**BEA Research  
Reactor Package**

**Safety Analysis  
Report  
Docket 71-9341**

**Revision 10  
May 2016**

### AREVA Federal Services, LLC Responses to NRC Request for Additional Information Dated March 31, 2016

Figure 1.2-17 – Cross Section View of BRR Package Showing Basket, Loose Plate Box, and Loose Plates

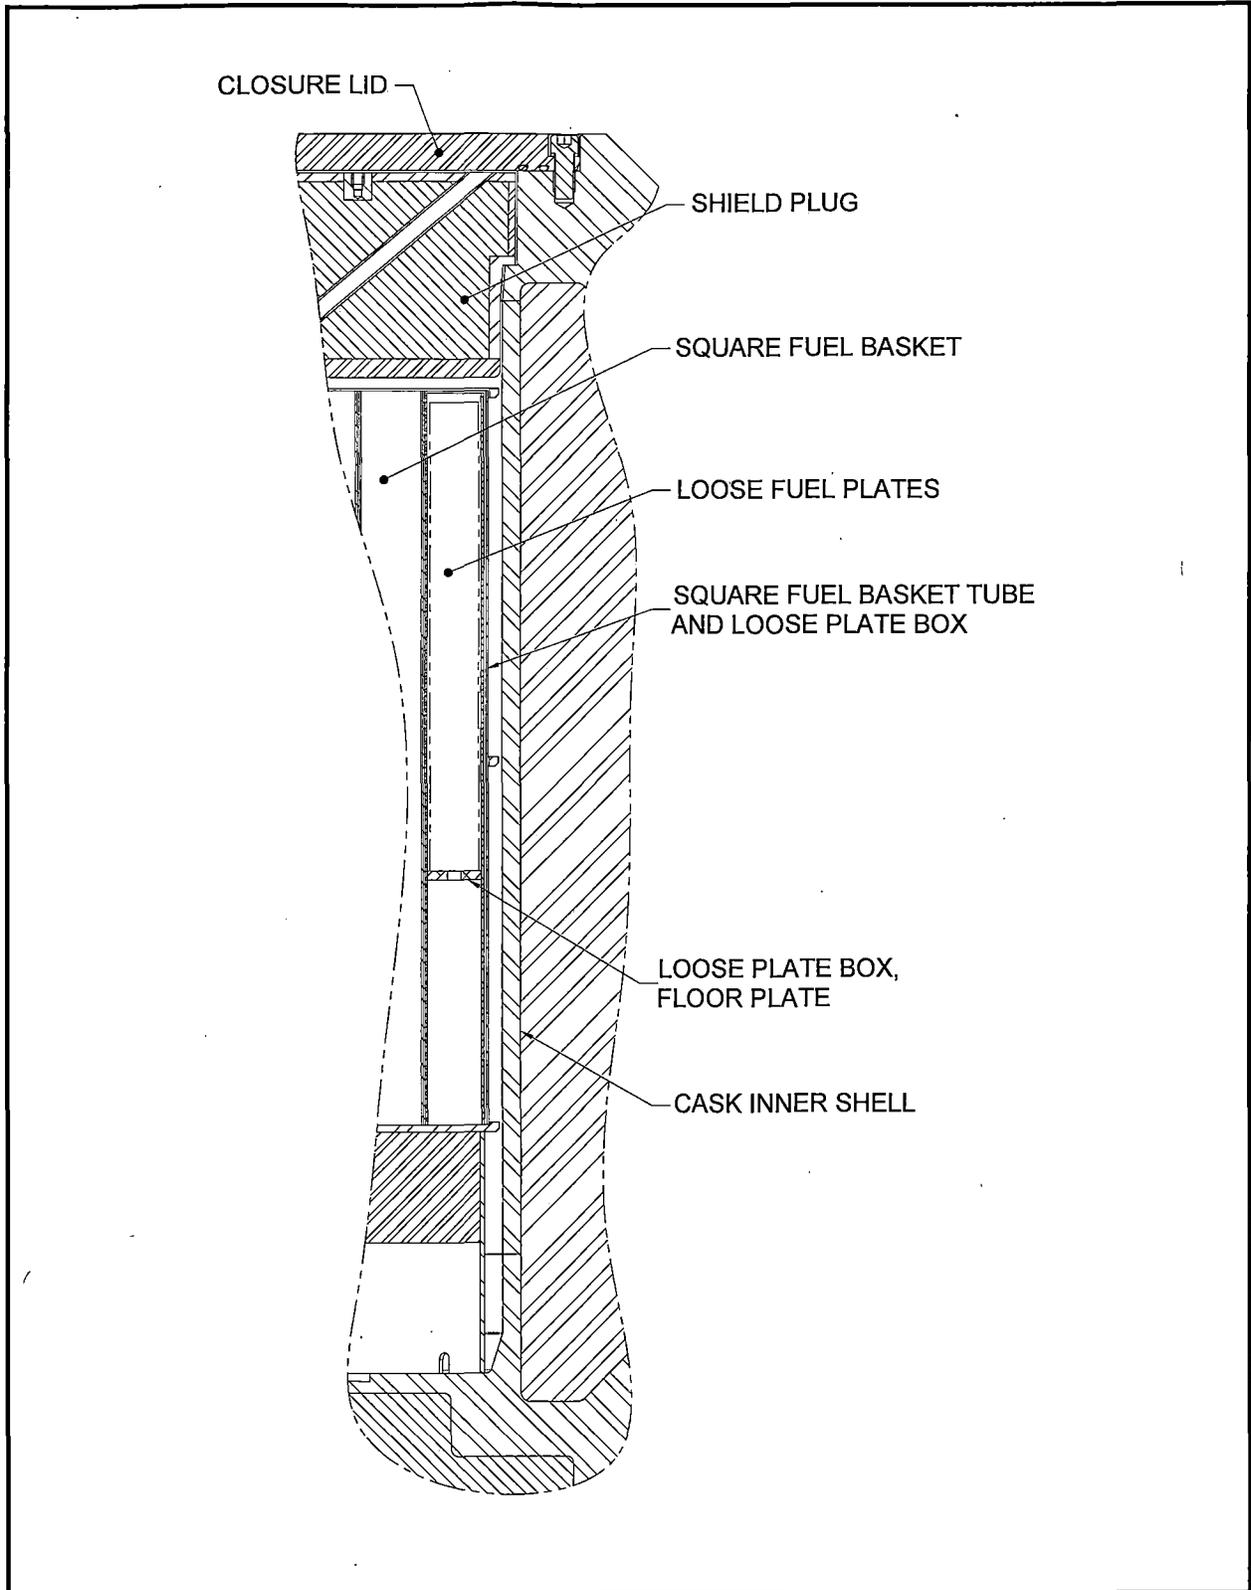
**Sh-5-2<sub>2</sub>.**

**Response:** Drawing 1910-01-01-SAR shows that the shield plug forms the top surface of the payload cavity, which defines the upper position limit for each of the baskets, as well as the fuel elements, loose plate box, and the loose plates. The loose plate box is designed to position the loose plates as close as practical to the top surface of the basket, and consequently there is relatively little clearance between the top of the loose fuel plates and the position limiting function of the shield plug. For this reason, the loose plates cannot move a significant distance in an axial direction, and cannot escape the confines of the loose plate box. Thus, no cover to the loose plate box is required. To assist in clarifying this matter, Figure 1.2-17 has been added to Chapter 1. This figure shows a cross sectional view of the cask cavity, the Square fuel basket, loose plate box, and loose plates.

In case the loose plate box is loaded with a partial load of loose plates, dunnage sheets must be used with the loose plates to restrict the unused space inside the box to a maximum of ¼ inches. The dunnage sheets are defined in detail in Section 7.1.2.1, *Wet Loading*, Step 12.b., and Section 7.1.2.2, *Dry Loading*, Step 12.b. These operational steps define the dunnage width, length, and minimum thickness. Further, a drawing of the dunnage sheets is given in Figure 7.1-1 (on the right side of the drawing). In this way, the possible movement of the loose fuel plates in all directions is limited.

<b>Section or page no. of change</b>	<b>Material changed</b>	<b>Reason for change</b>
1.2.2.5	Added reference to Figure 1.2-17	Update.
1.2.3	Updated discussion of plutonium	To strengthen the discussion of the plutonium source term.
Figure 1.2-17	Added figure	To help clarify the configuration of the loose plate box in the square fuel basket.

Figure 6.4-7 – LPB Loading/Unloading

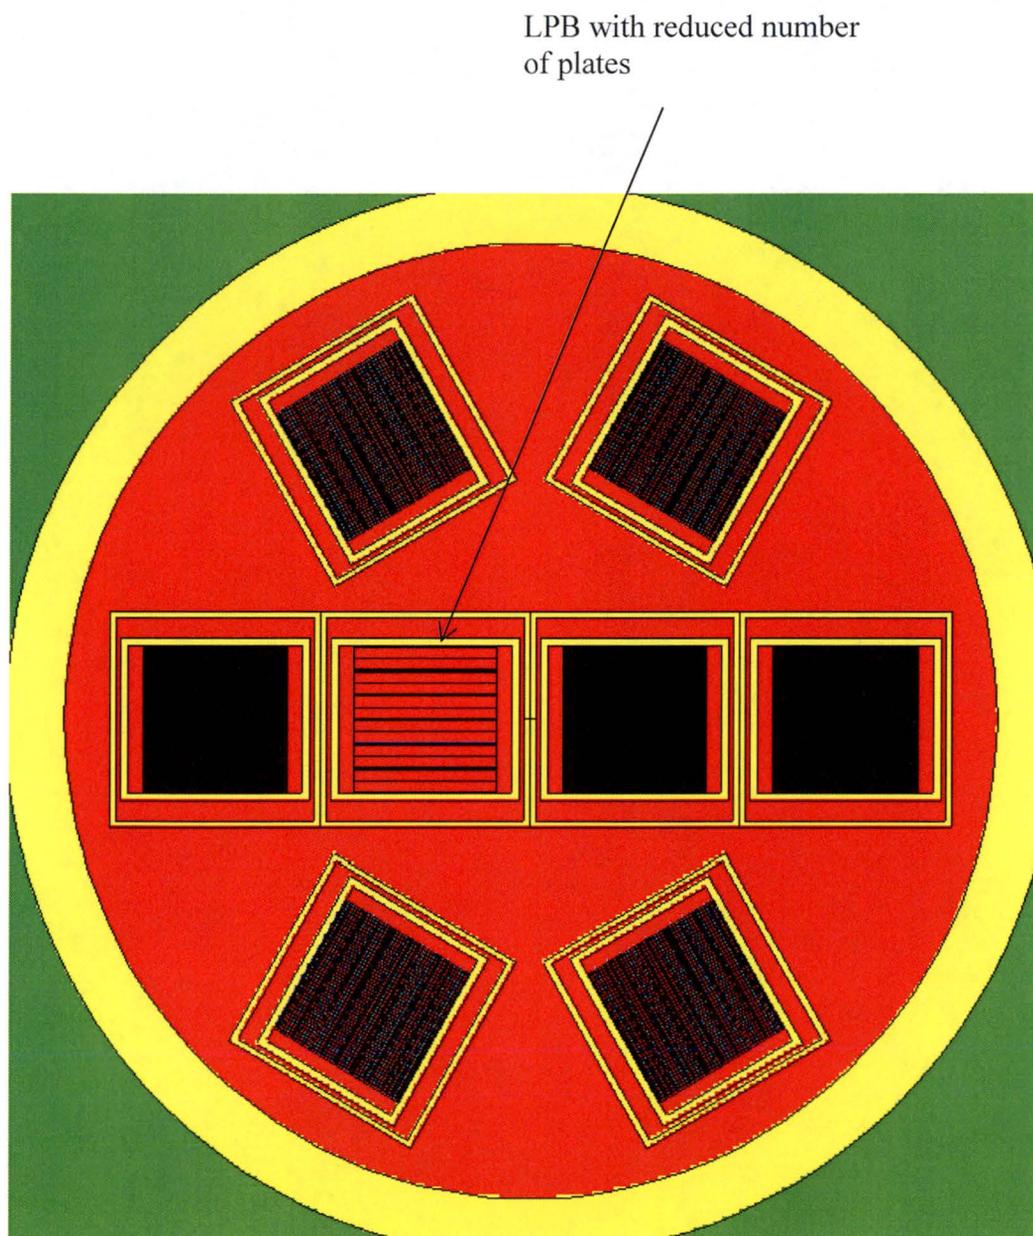
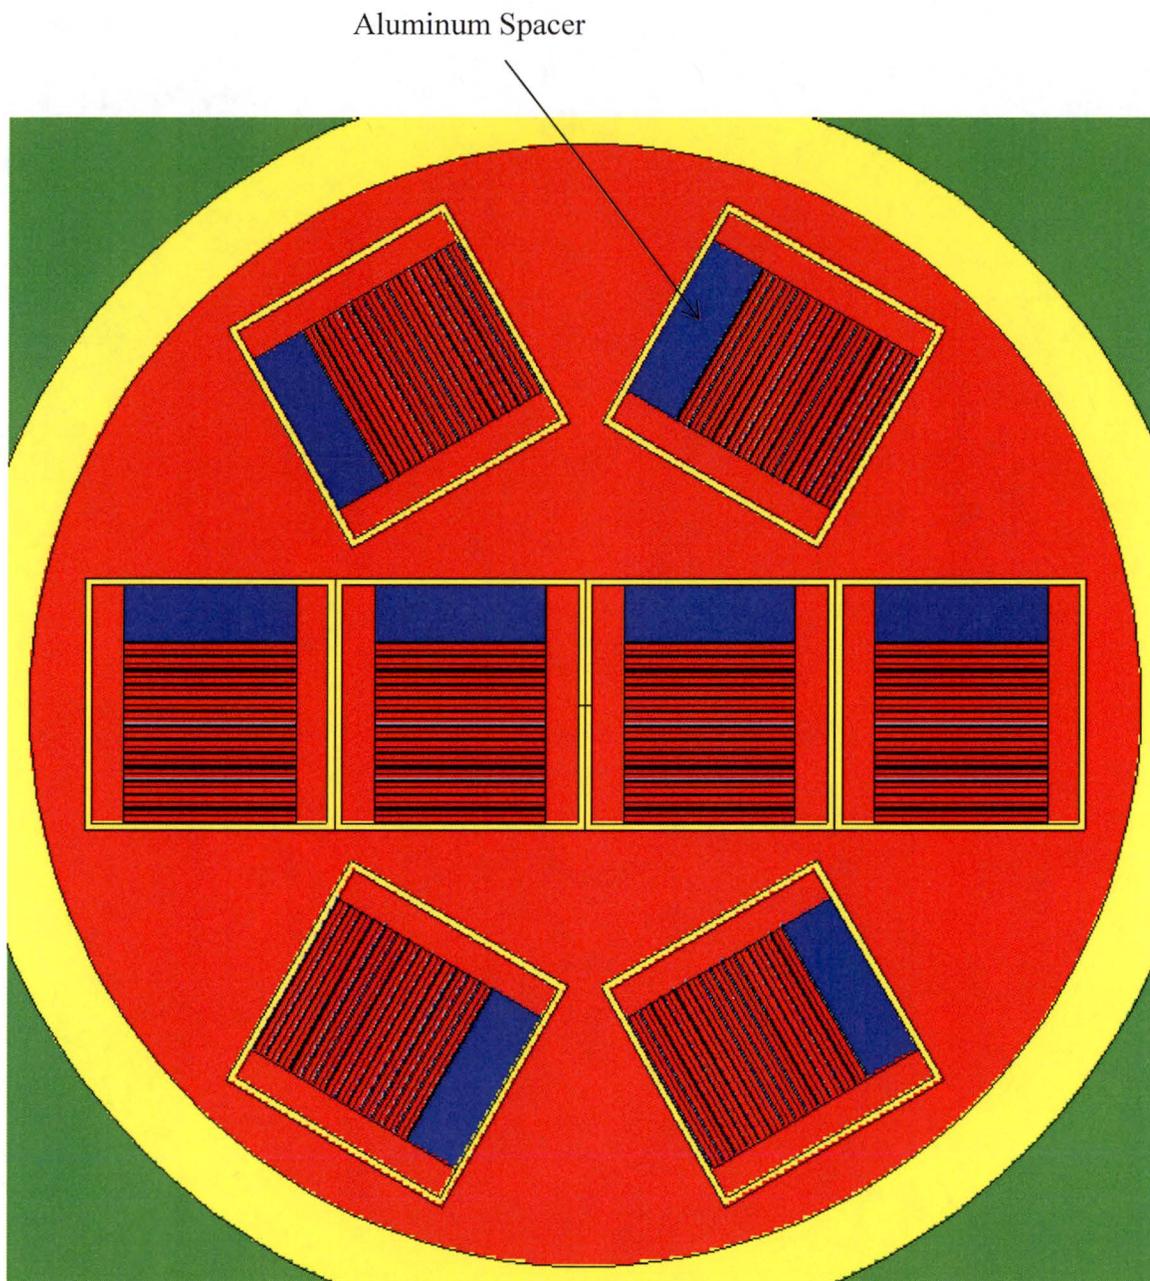
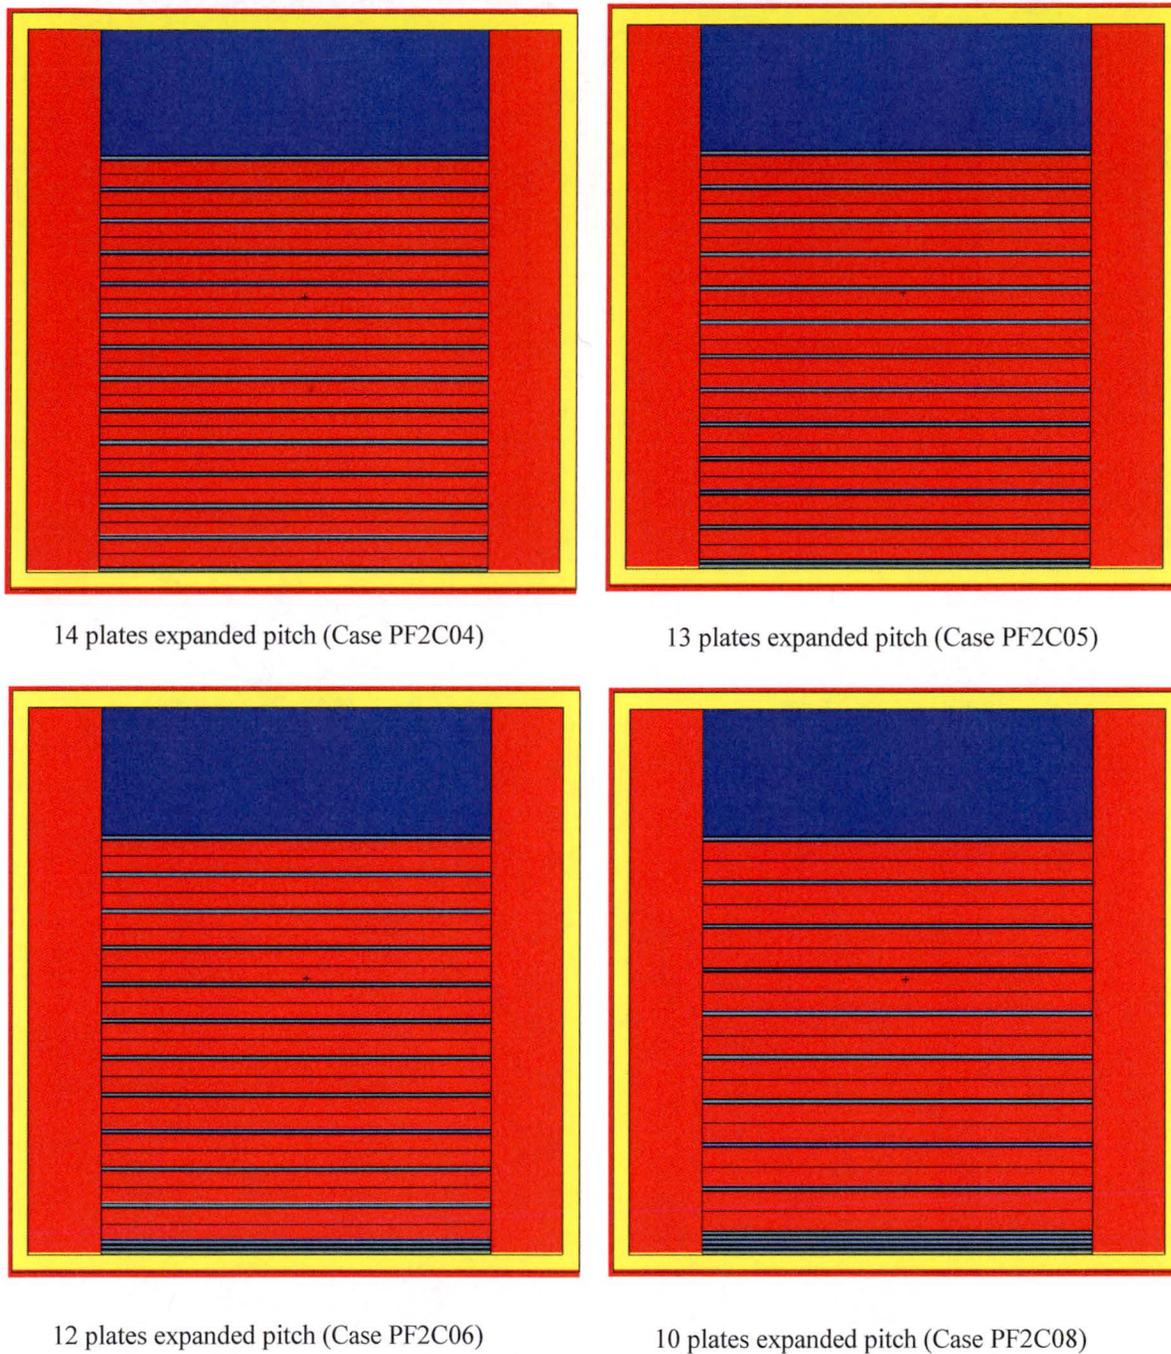
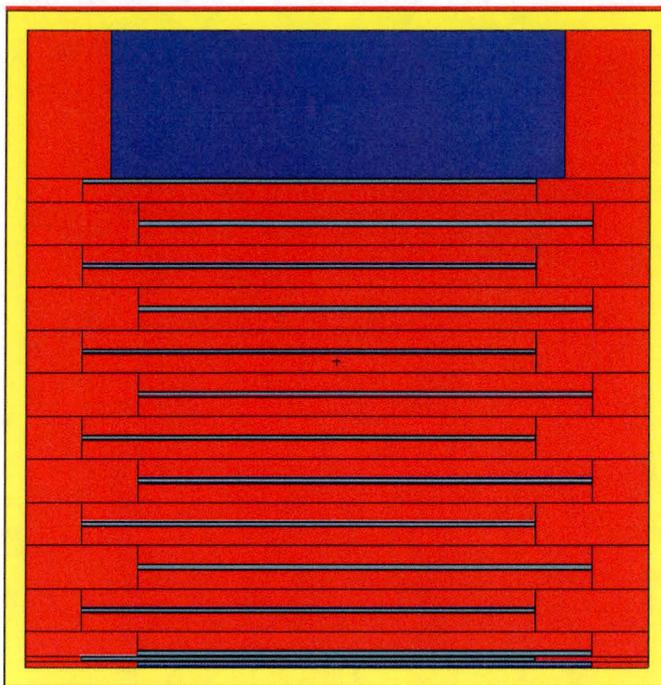
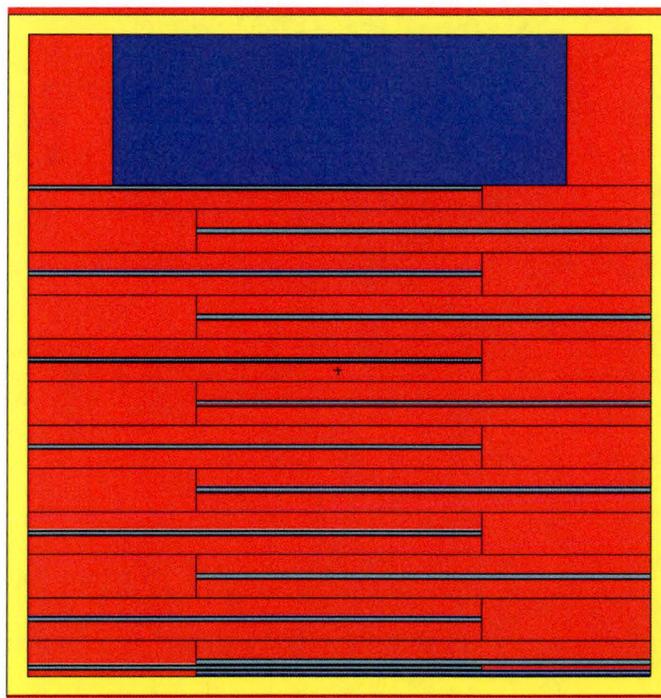
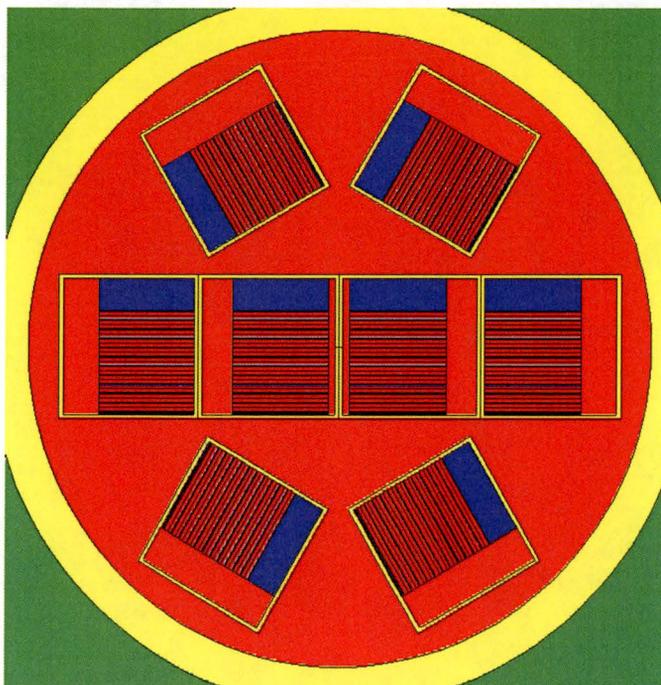
This instruction seems to leave the users to determine if dunnage is necessary. However, the criticality safety analyses credited the dunnage as shown in Figures 6.4.7 to 6.4.11 of the application. This instruction could lead to a potential criticality safety accident as it stands because the instructions seem to indicate that the dunnage is an optional component of the packaging but it is in fact a component important to safety because the criticality safety of the package is dependent on the dunnage. The applicant also needs to revise the Operating Procedures to provide clear instructions for the use of dunnage.

**Response:** The text of Section 7.1.2.1, *Wet Loading*, and Section 7.1.2.2, *Dry Loading*, has been revised to prevent the confusion between *spacer plates*, which pertain only to U-Florida fuel elements, and *dunnage sheets*, which pertain only to loose plates. The use of spacer plates with U-Florida fuel elements has always been required by the procedure. These spacer plates (not dunnage) are the items shown and credited in Figure 6.4-7 through Figure 6.4-11 of the application. The SAR has been revised to also require the use of dunnage sheets to reduce the gap between the loose plates and the loose plate box to ¼ inches or less. (Note: dunnage sheets are not required if the gap is already equal to ¼ inches or less, without them. Thus, the words “as necessary” are still present, because
